Community Development Department – Planning Division

## REPORT TO PLANNING COMMISSION

**SUBJECT: 5800 Northgate Drive (Northgate Town Square Project)** – Study Session for the proposed Northgate Town Square Project (PLAN 21-039) (also referred to as the Northgate Mall Redevelopment Project), which includes requests for a Rezone to the Planned Development (PD) zone (ZC21-001) and an associated Development Plan, a Master Use Permit (UP21-007), an Environmental and Design Review Permit (ED21-024), a Vesting Tentative Map (TS21-002), State Density Bonus Law approvals including the provision of one concession/incentive to increase the permitted height to 78-feet for all buildings and structures in Phase 1 (2025) and Phase 2 (2040), and a Master Sign Program (SP24-002) to allow a comprehensive redevelopment of the existing mall at 5800 Northgate Drive into a phased mixed-use development with approximately 217,520 square feet of commercial space and 1,422 residential units on the 44.76-acre site. APNs: 175-060-12, -40, -59, -61, -66, and -67; General Commercial (GC) District, Merlone Geier Partners, LLC, owner/applicant of entire site. In addition to these entitlements, the applicant wi

**Figure 6: Residential 1 Rendering (Original and Revised)**

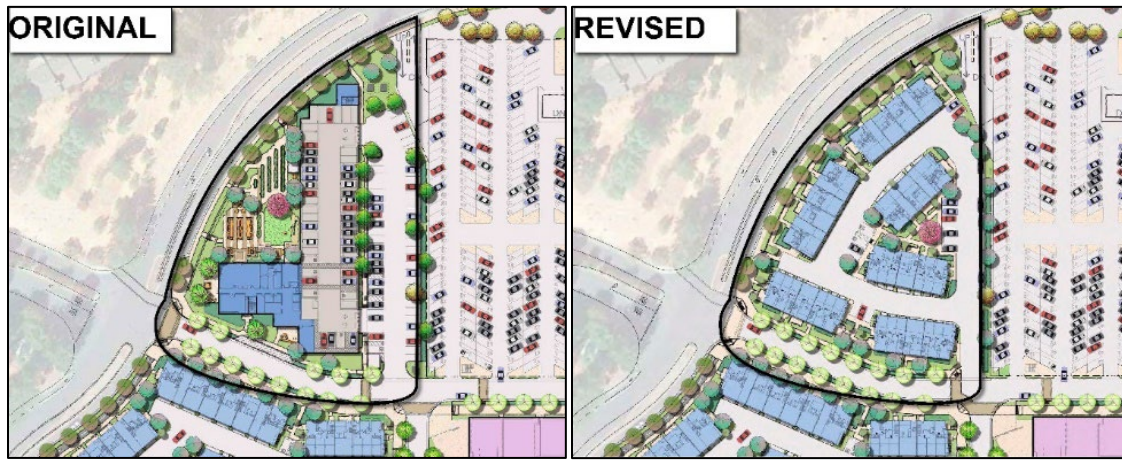
One of the most significant revisions to the overall project layout in the June 2024 submittal is the removal of the EAH affordable housing component on Residential 1 and the associated addition of 38 townhomes. This modification changed both the overall affordable housing programming as discussed below, but also resulted in a reduction in massing on Residential 1. These modifications were selected by the project applicant as an alternative approach to meeting the City's inclusionary housing requirements. Additionally, the applicant determined that the modifications would help address complexities associated with timing for project implementation. The elimination of the five story EAH building on Residential 1 also helped to address general

feedback concerned with the overall massing of the project, especially in relation to neighboring lower density residential uses.

The applicant modified the proposal in the revised project to eliminate the EAH building on Residential 1, replacing the 96-unit apartment building with 38 three story townhomes that together with Residential 2 provide a total of 138 for-sale townhome units. To maintain the 1,422 units in the overall project, an additional 58 apartment units have been incorporated into the revised Residential 5. This modification resulted in architectural modification to Residential 5 to including an increase in building height from 5-stories to 6 stories.

**Figure 8: Town Square (Original and Revised)**

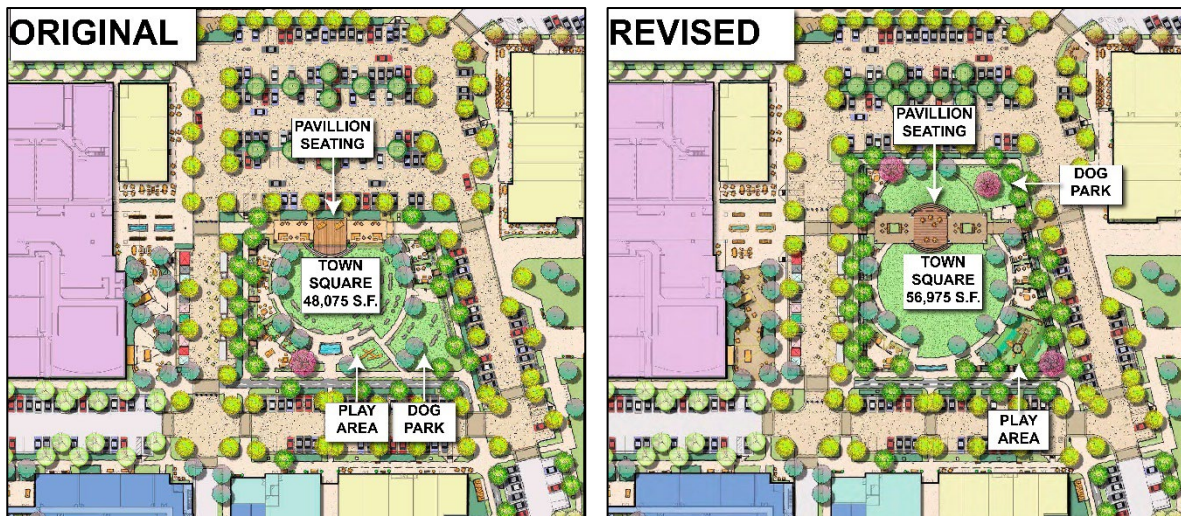
There were a number of comments from members of the public, DRB, and Planning Commission that were the focus of revisions to the Town Square. A common theme was the request for enlargement of this common amenity. Additional comments asked for inclusion of features for all

The revised project increased the size of the Town Square from 48,075 square feet to 56,975 square feet by incorporating a row of parking to the west of the Town Square. The applicant has committed to use of natural grass and eliminated the seating boulders in the lawn area to allow for more flexible use of the lawn area for activities. The dog park was relocated within the Town Square away from the children's play area but remains in the project based on market demands for the residential uses being introduced on the site. Modifications to landscaping in the Town Square better utilizes specimen trees for shading and interest.

**Figure 10: Cinema Building (Original and Revised)**

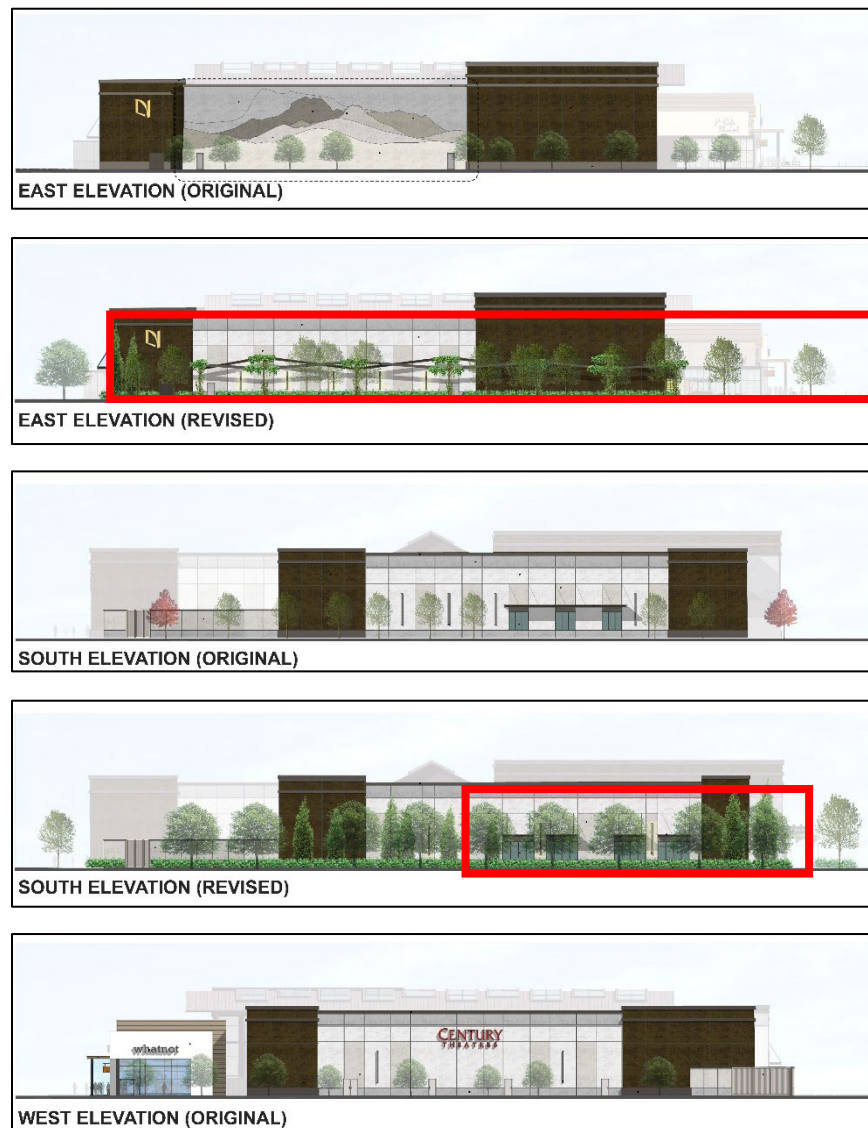
providing a landscaped green screen or other design solution to break up the rear façade of the cinema structure across from the town homes. In response to that feedback the revised project includes the following design modifications.

- Removal of the mountain relief feature on the east elevation
- Addition of a trellis and more robust tree planting along the east side of the building
- Addition of windows and sunshades on the south elevation, facing the townhomes
- Increased planting along the south elevation to further screen the elevation from the neighboring townhomes
- Increased landscaping along the west elevation to screen and provide relief from the large massing

These modifications are shown in the elevations in Figure 10 below and generally in the renderings in Figure 11.
